REMARKS

METHOD AND DEVICE FOR THE CALIBRATION-EQUALIZATION OF A RECEPTION SYSTEM

Application No. 10/669,691
Inventor: Pascal CHEVALIER et al.

FIG.1

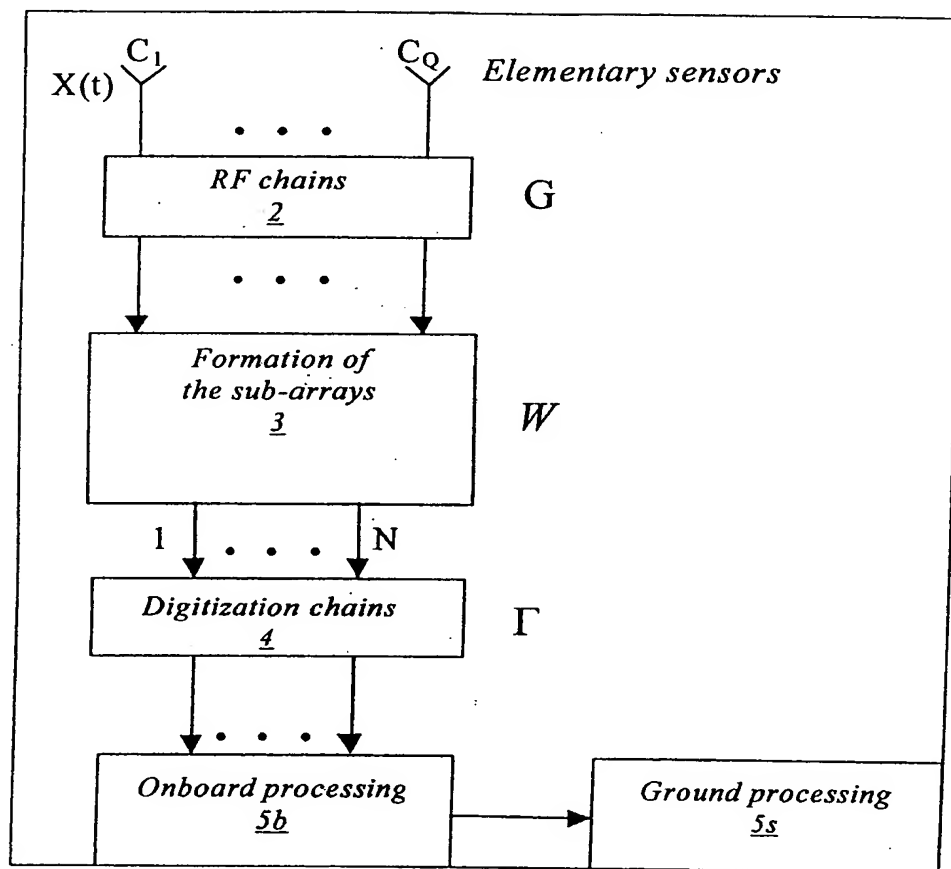
Figures 1-5 were objected to as not being designated to by a legend such as "Prior Art". In response, attached to this Amendment are Annotated and Replacement drawings for Figures - 1-5 designated as "Prior Art". Accordingly, this objection should be withdrawn.

~~PRIOR ART~~

FIG.2

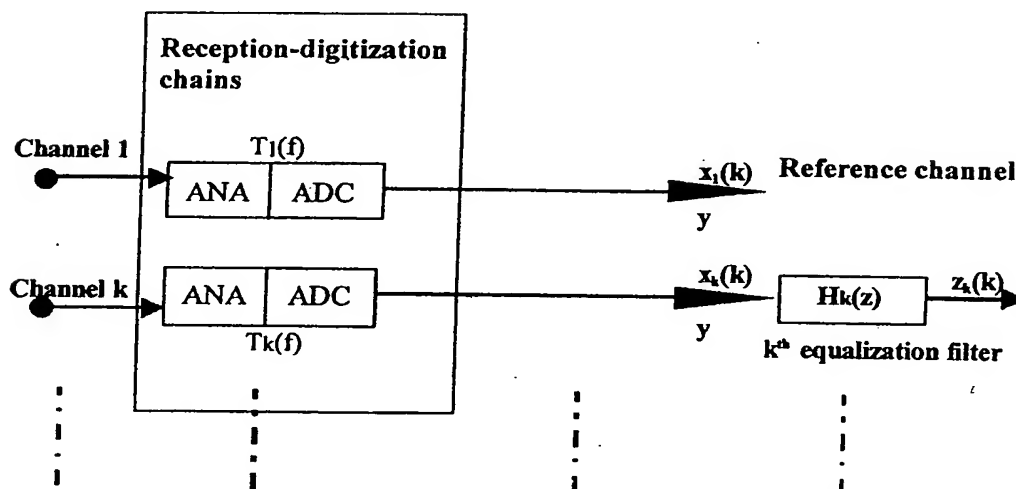
~~PRIOR ART~~

FIG.3 PRIOR ART

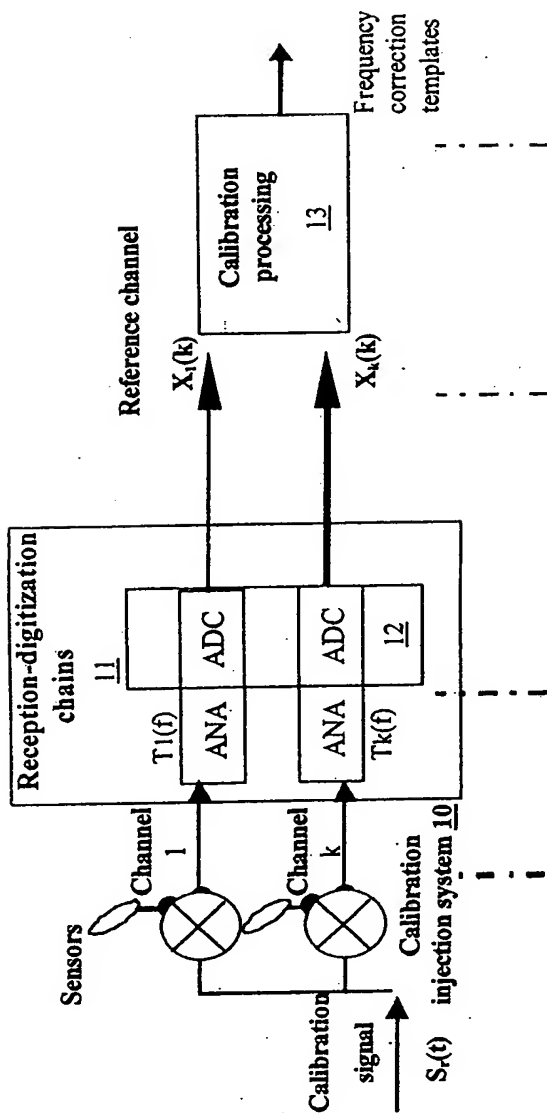
Applicants mention example of way to overcome the limitations in paragraph "C-Equalization of the reception chains". For example, Figure 3 shows a classically used generic calibration system. This system uses a "classically, a switch-based system is used" and fails to describe the characteristics of claim 1 of the present invention.
